Aqueous Solutions (owner) AQS-MFG-GLASS_DIGEST-NOZZLE_ORIENT
GLASS_DIGEST fabrication drawing NOZZLE_ORIENT (AQS-PLAN-006
Type: fabrication drawing (GA / nozzle orientation / part sheet) Rev 34833cdb Issued
Created: flow graph pipeline Approved: not approved (study)
Sheet 1 of 1 AQS-DWG-001

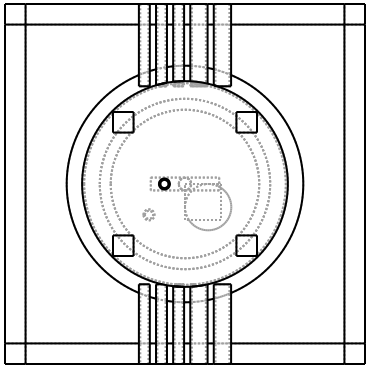
Graph revision AD - nozzle_orient: 12 schedule rows of docs-authority/nozzles/GLASS_DIGEST.csv at tag, face and bore - the issued schedule replaces the 5-ro
Graph revision AD - nozzle_orient: Inlets N1-N4, N12 on -Y; outlets N5-N8, N11 on +Y; the placeholder datums (160/600) draw clamped into the shell span [17
Graph revision AD - nozzle_orient: N9 drain boss flush at the envelope bottom; N10 vent riser on the lid flush at the
Graph revision AD - nozzle_orient: Atmospheric open-bore tube connections per duty section 4; the N11 solids row
